VW Polo (9N)

All vehicles with 1.9/74 KW pump-jet engine

Replacement of the coolant pump

Bulletin

Fig. 1

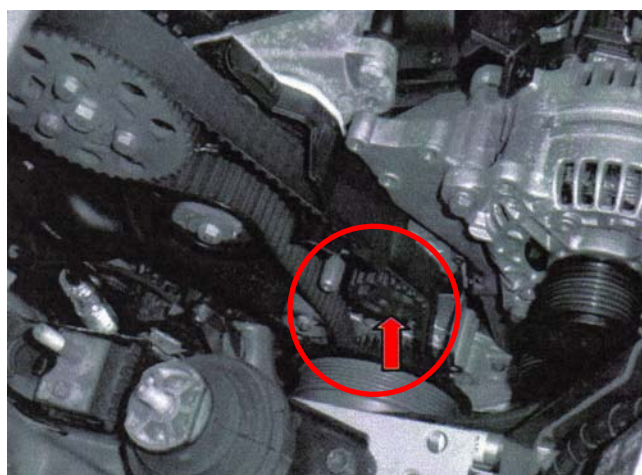
In the case of some of the above-mentioned vehicles, an incorrect water pump was fitted at the factory. The fitment of an incorrect gear on the pump means that there is the possibility of the belt jumping. These vehicles should therefore be checked for this, such as during a service, for example. The fact that a check has already been made can be seen from the sticker with the inscription "19D5" (see Fig. 1), in the area of the spare tyre well. If the sticker is not present, proceed as follows:

- If the gear with the correct number is fitted, the vehicle can be reassembled.
- If the wrong gear is fitted, replace the coolant pump and the timing belt.
- After the repair, the sticker should be affixed in the spare tyre well. The sticker can be obtained via the

Fig. 2

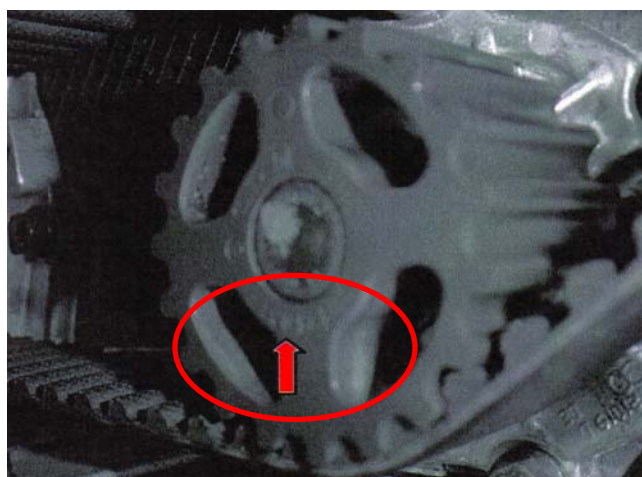
- Remove the timing-belt cover.
- Turn the belt drive until the part number on the face of the gear can be seen (see Fig. 2).

Correct number: 038 121 031F

Incorrect number: 038 121 031G
